July 16, 2020

Acoustical Analysis Peer Review DRAFT

Cortona Drive Battery Energy Storage System

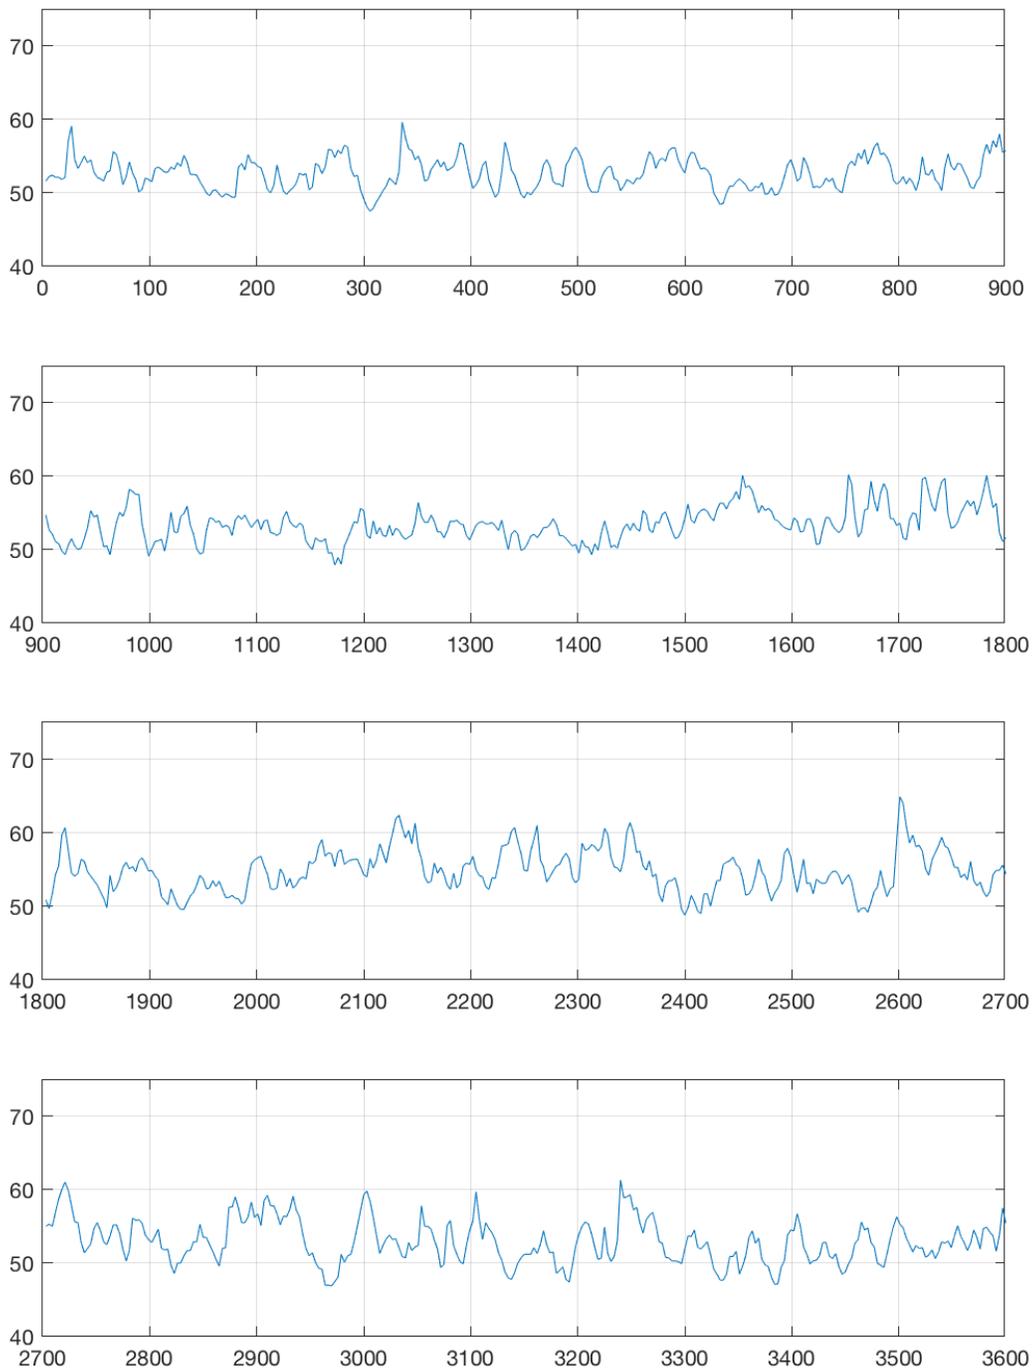
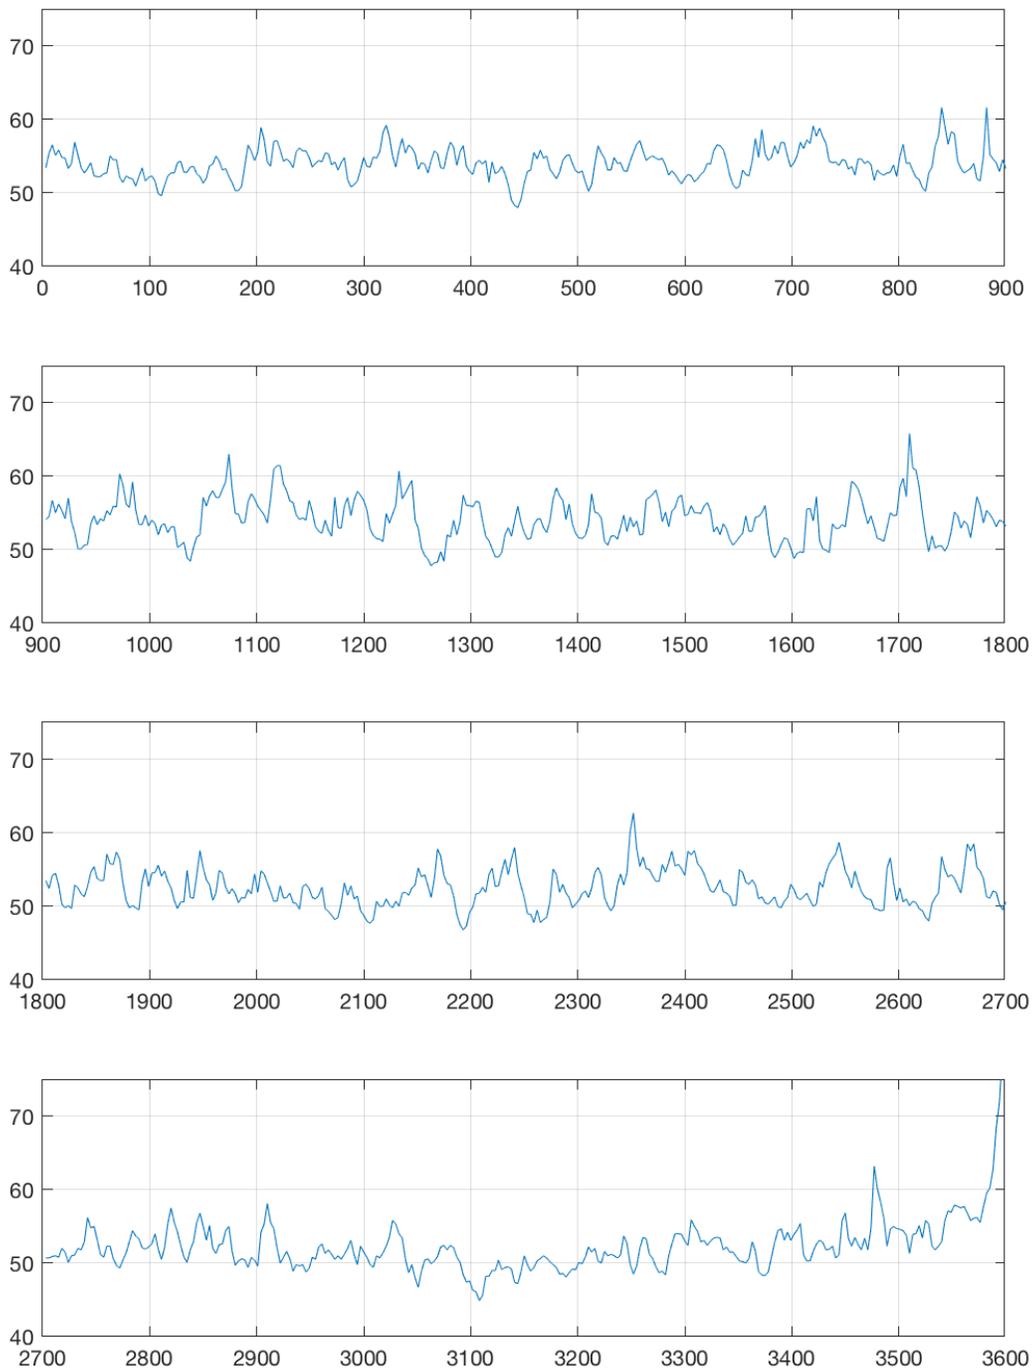
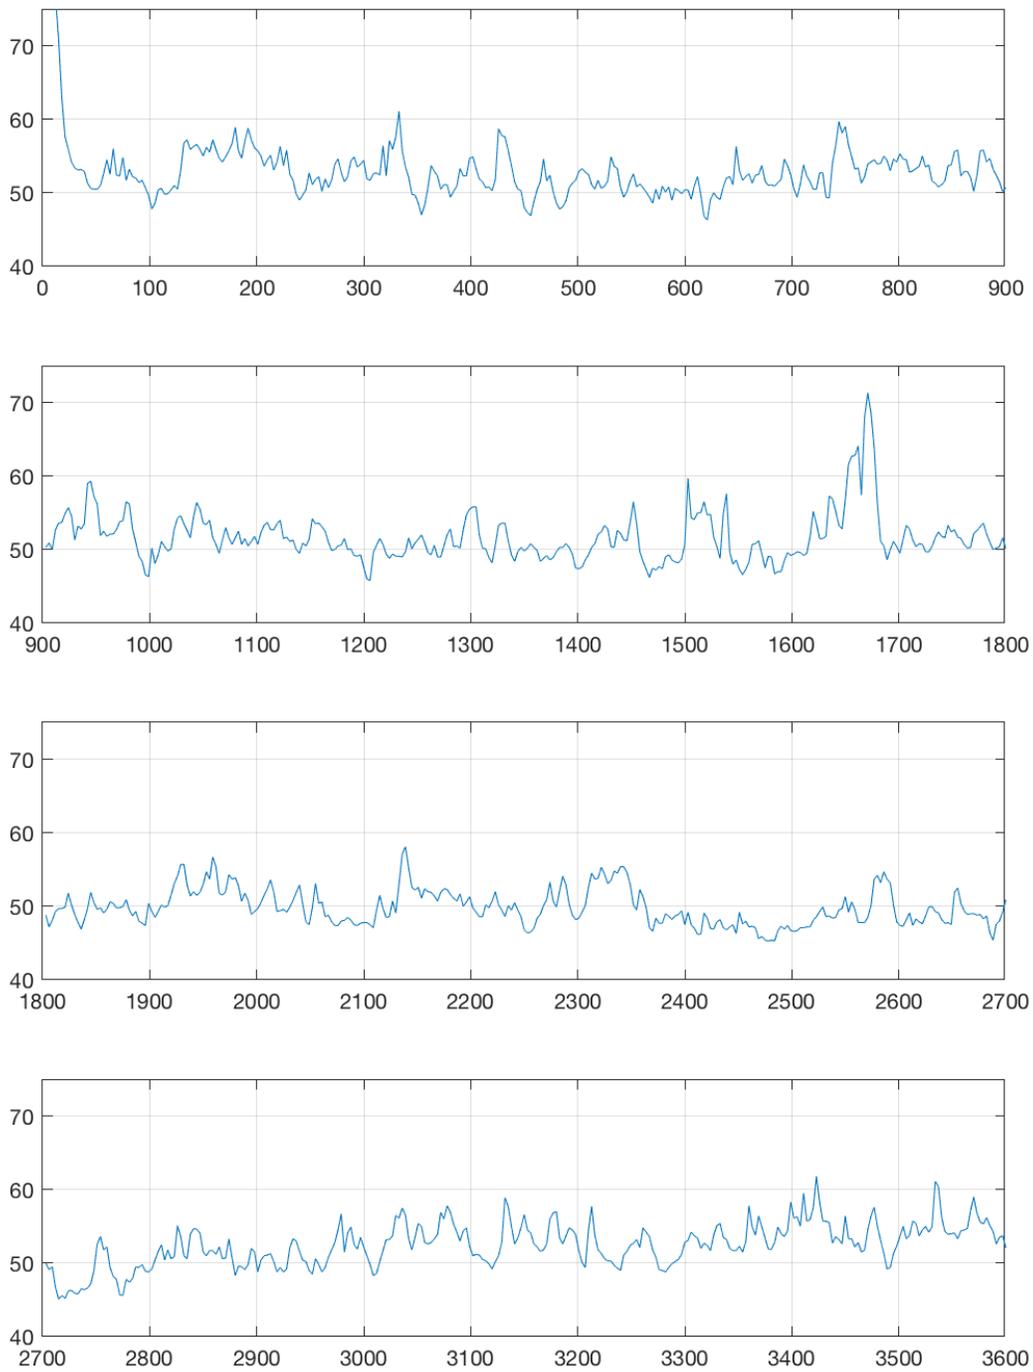
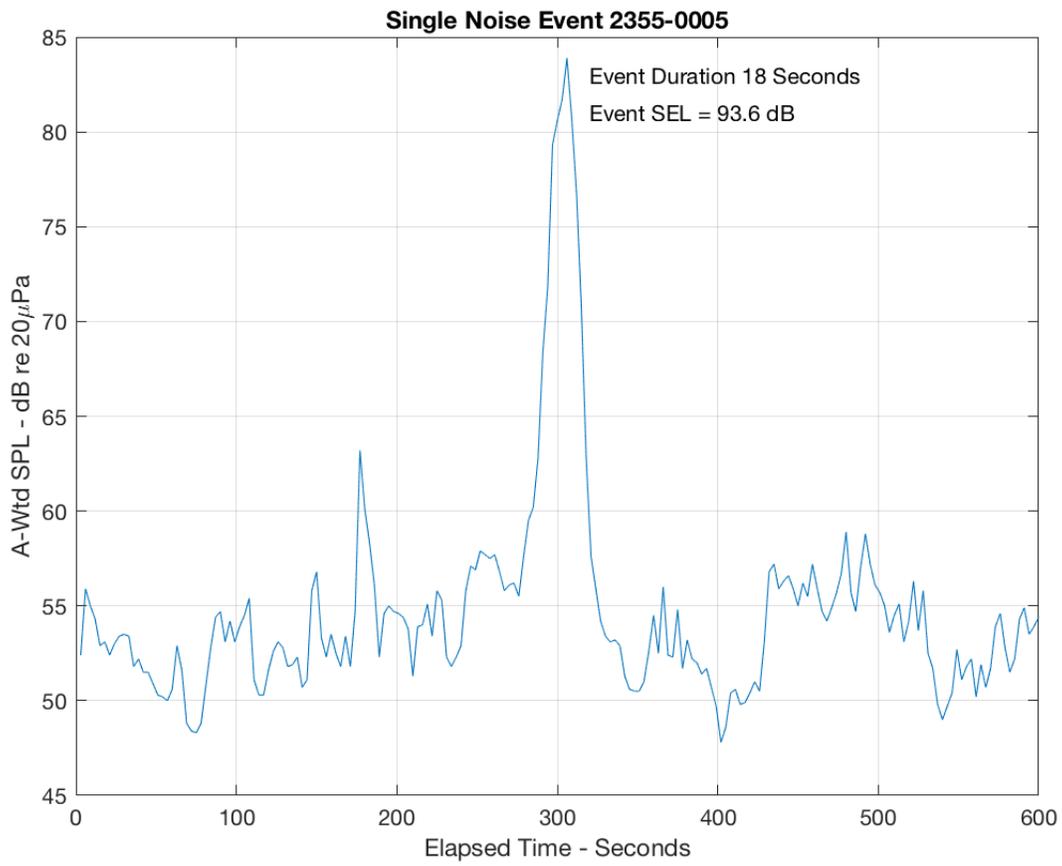
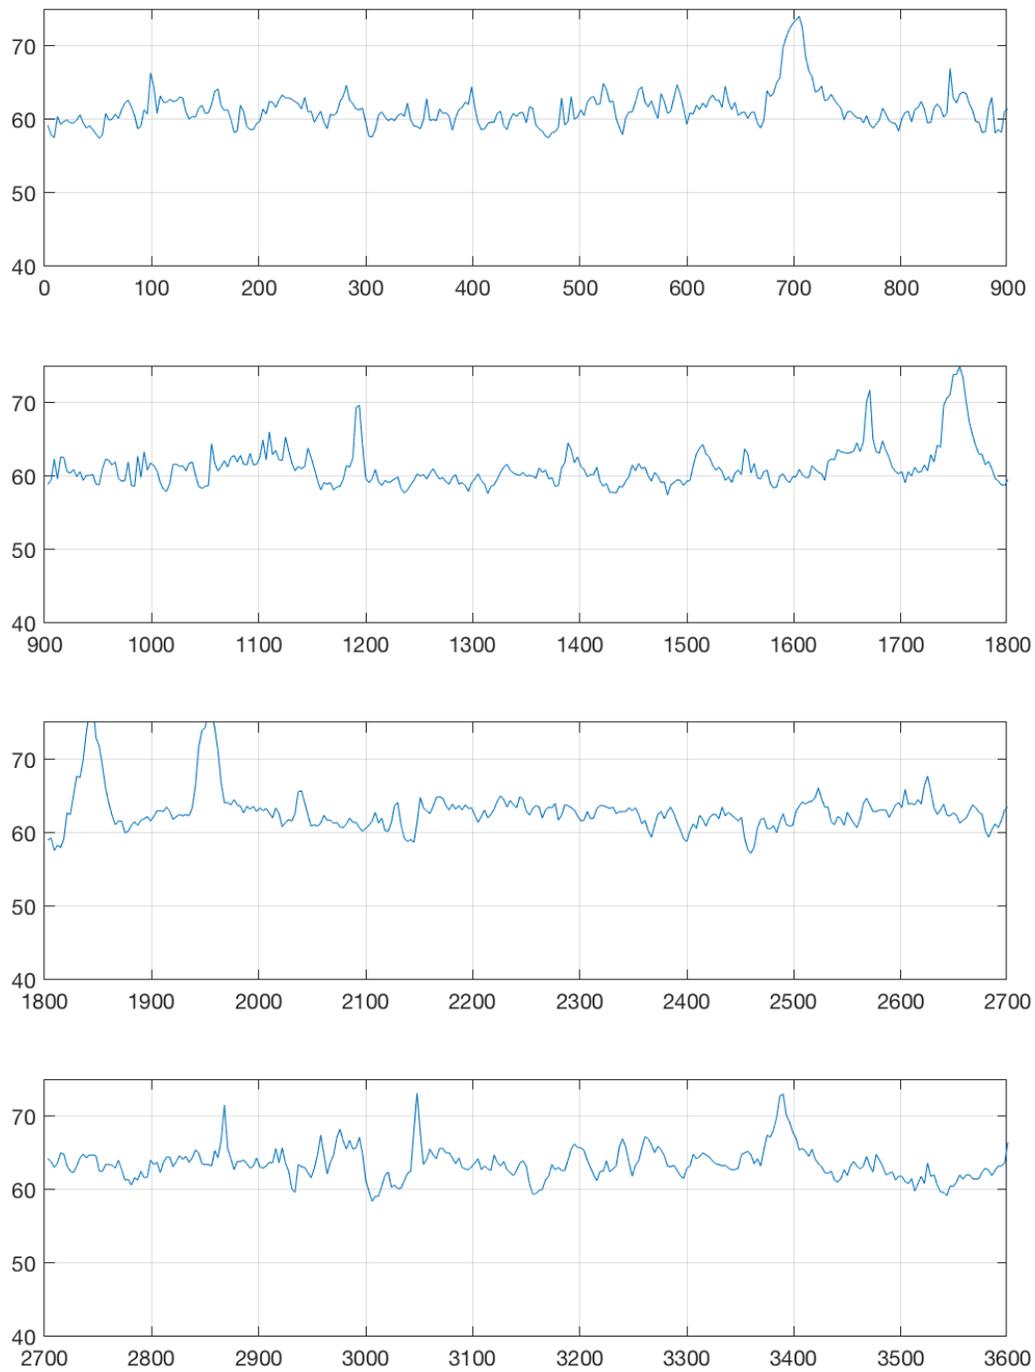
Existing Noise Setting – The graphs in Figures 3 and 4 of the Report are helpful for evaluation of ambient conditions. A statistical analysis would also be helpful, and in fact was provided in an earlier Draft. Note that the level is below 55 dB most of the time in mid-morning, with average (L_{eq}) 57 dB at both locations. On Table 2 of the Report, note that from 9-12 p.m. the L_{eq} is 54-56 dB, while the L_{eq} from 10-11 a.m. is 56 dB, suggesting that the nighttime environment is not radically different than that measured in mid-morning. To help illustrate the ambient conditions, representative segments of the long-term measurement data (from earlier Report Draft) have been graphed and statistically analyzed. Figure 1 below shows plotted results of the long-term measurement in the 10-11 p.m. hour. Figure 2 show the 11 p.m. to midnight hour and Figure 3 shows midnight to 1 a.m. Note that an "off-scale" noise event appears to be occurring right at midnight. Figure 4 shows a 10-minute segment of the measurement data centered on this 18-second event. Finally, Figure 5 shows the time history of noise in the final

“nighttime” hour, 6 – 7 a.m. This hour’s noise is penalized by +10 dB for purposes of computing CNEL.

It is important to assess the ambient environment in more detail than a single CNEL because of the disparity in character between existing traffic and railroad noise and the proposed array of mechanical and electrical devices. Presence of spectral peaks (tones) and different variability patterns are two potential annoyance factors.

Table 1 summarizes the statistics of noise from the four plotted time periods and the two short-term mid-morning measurements. Late at night and during mid-morning, the median (L_{50}) ambient level is in the range 50-55 dB and the background (L_{90}) level is just below 50 dB. The Sound Exposure Level (SEL) is equal to L_{eq} plus $10 \log_{10}(\text{Duration in seconds})$.

Figure 6. Tesla Cooling Fans Total Sound Power Level vs Drive Setting

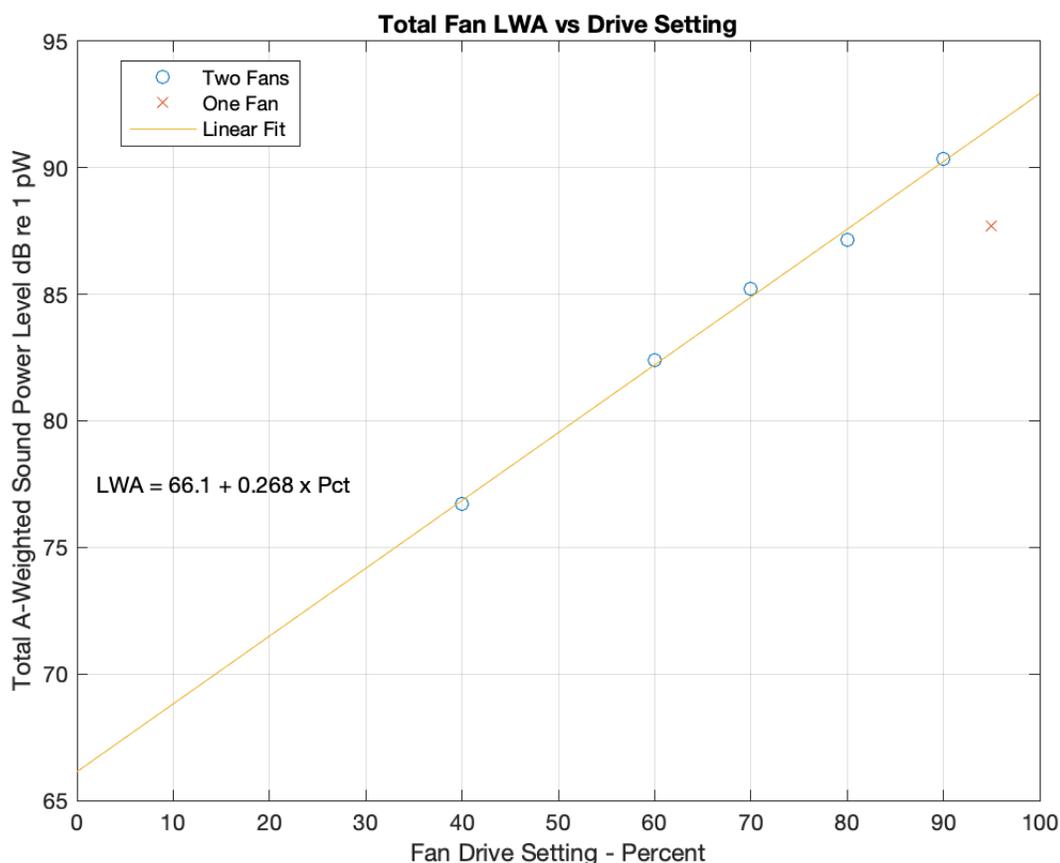
Noise Sources – No table is provided showing the locations of all noise sources, although they are identified on the Site Plan in Attachment 1. Spectral data is not provided for transformers and sub-station. Considerable detail regarding the cooling fans has been provided, but the application of this data is unclear. The Report appears to discard the data for two fans operating at the 40% setting on the basis of potential cancellation between the two fans. The tone level of two fans operating at the same speed but at different phases would be subject to

uncertainty, but the overall level would be reasonably reliable. To avoid this uncertainty, the Report computes a 40% single fan level from the 95% single fan level, but appears to have only used the “Top” sound power level in the data (78.7 dB re 1pW). The actual sound power is the sum of the five measured components (LWA = 87.7 dB re 1pW). The total LWA for the various test settings are shown in Figure 6 and the third-octave spectra for single fan at 95% and two fans at 40% are shown in Figure 7. The Report subtracts 4 dB from the 78.7 dB to obtain a single fan sound power level 74.7 dB. It would be more appropriate to subtract 3 dB from the true LWA of 76.7 dB to obtain 73.7 dB. Serendipitously, this is only 1 dB lower than the value modeled in the Report. However, note in Figure 7 that the computed octave band SLA spectrum (from Report Attachment 6) does not track the 40% LWA spectrum, particularly in the range around 200 Hz where the blade passage tone occurs at 40%.

Figure 7. Third-Octave A-Weighted Sound Power Level Spectra (Receiver 9-3 is Octave Band SLA in dB re 20 μ Pa)

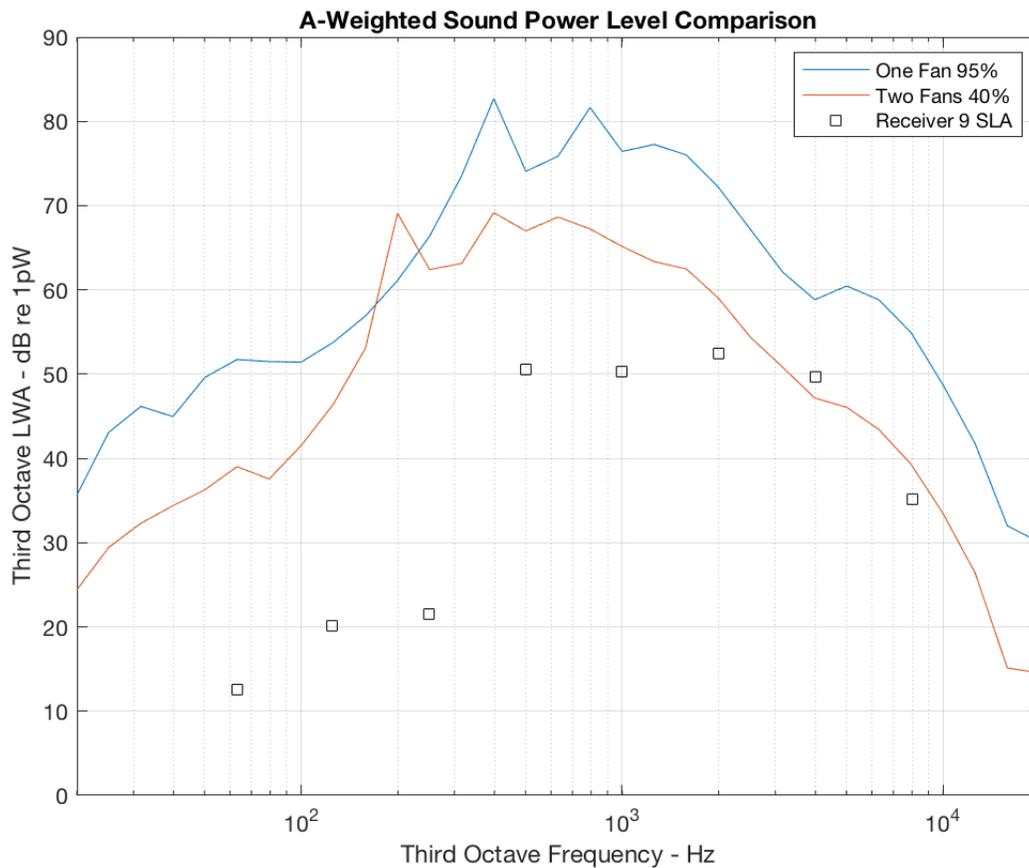
The 1/3-Octave spectra in Figure 7 show clear indication of peaks at Blade Passage Frequency (BPF), 2BPF and 3BPF, both at 40% and 95%. The BPF Tone Prominence, defined as the SPL in the BPF third octave minus the average of the SPL's in the two neighboring third octaves, was computed for each set of data from Tesla, as shown in Figure 8. Typically, Tone Prominence triggers a penalty if it exceeds 8 dB for frequencies up to 400 Hz, and 5 dB above 400 Hz. The 40% Tone Prominence is 11 dB at 200 Hz, so whatever tonality penalty is suggested in the Municipal Code sections would be applicable.

Figure 9. Summing Two, Three, Six or Ten Equal Tonal Sources with Random Phases

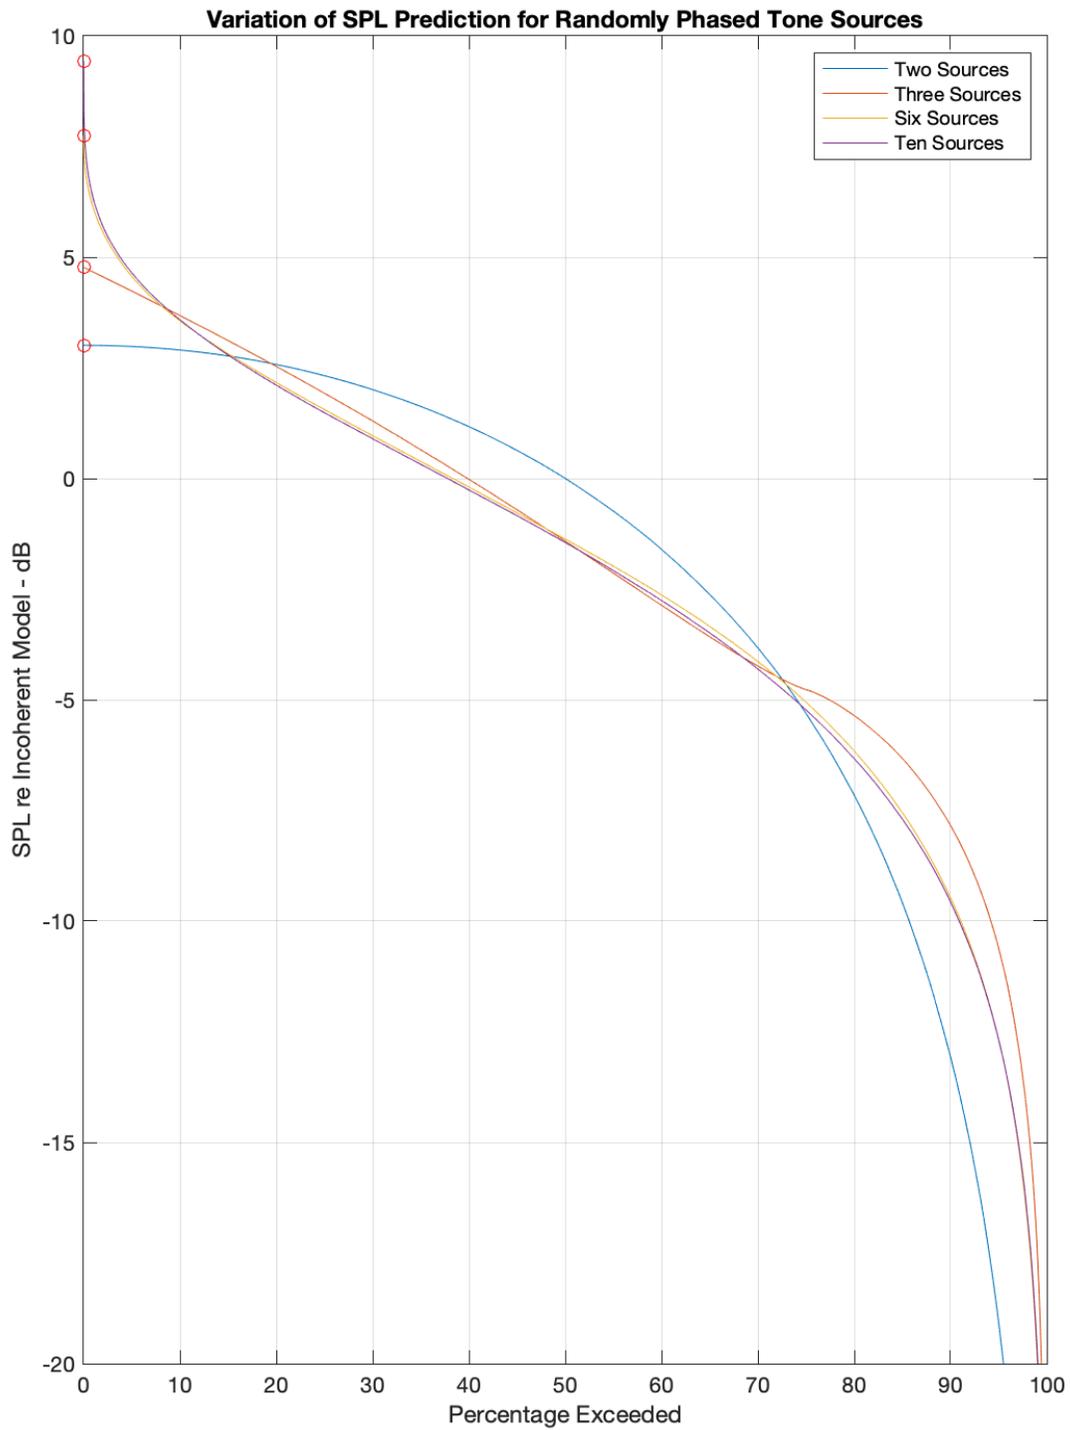
A further problem with tonal sources is that ISO 9613-2 treats individual sources as statistically independent, so that adding two sources results in +3 dB compared to each, i.e. the powers add. In actuality, the pressures add and the total depends on the correlation between the two sources. If the sources are tones, the correlation R_{12} is the cosine of the phase between the two sources and varies between +1 and -1. Power is proportional to pressure-squared, so adding two pressure signals $p_{1+2}^2 = p_1^2 + p_2^2 + 2 p_1 p_2 \cos(\text{Phase}_{12})$. The third (coherence) term causes the pressure sum to vary between +3 dB and $-\infty$ dB compared to simply adding the energies. With a large number (N) of sources, the possible underprediction is $10 \log_{10}(N)$, although the probability of encountering the maximum is very low. As shown in Figure 9, with two sources, there is an equal chance of over or underpredicting the sound level by ignoring coherence effects. With three or greater numbers of sources, there is approximately 40% probability of underprediction and 60% probability of overprediction, with a very small (3%) probability of underprediction by more than 5 dB. [Note that these calculations were done for one million random combinations of source phases. Even with this large number of trials, the theoretical maximum of +10 dB for ten sources was not observed.]
